MEMORANDUM

Preliminary Plan of Subdivision

PROJECT NAME: Monty

120090060

Attachment C – Proposed Development Plan

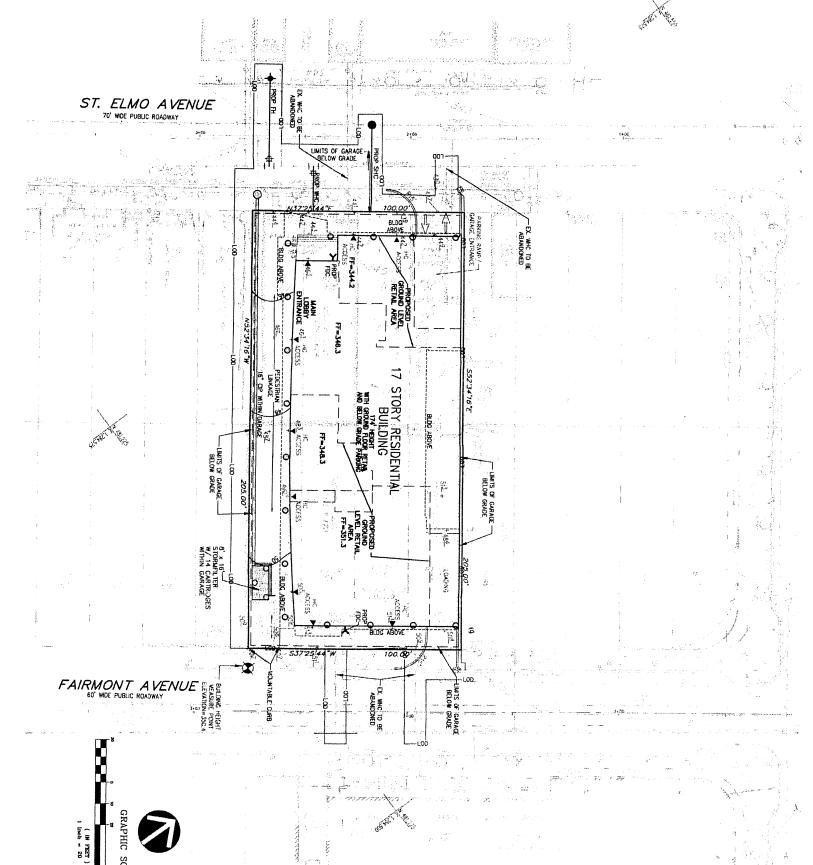
- 1. Grant necessary slope and drainage easements. Slope easements are to be determined by study or set at the building restriction line.
- 2. The vehicle turning movement plan provided by the applicant is acceptable. A note is to be placed on the preliminary plan indicating that a WB-40 vehicle is the largest vehicle that can be accommodated by the loading area on Fairmont Avenue.
- 3. Curb radii for intersection type driveways must be sufficient to accommodate the turning movements of the largest vehicle expected to frequent the site.
- 4. The sight distance study is acceptable. A copy of the accepted sight distance evaluation form is enclosed for your information and reference.
- 5. The drainage study is acceptable.

- 9) The certified preliminary plan must include a note stating that a WB-40 vehicle (40-foot wheelbase) is the largest vehicle that can be accommodated by the loading area on Fairmont Avenue.
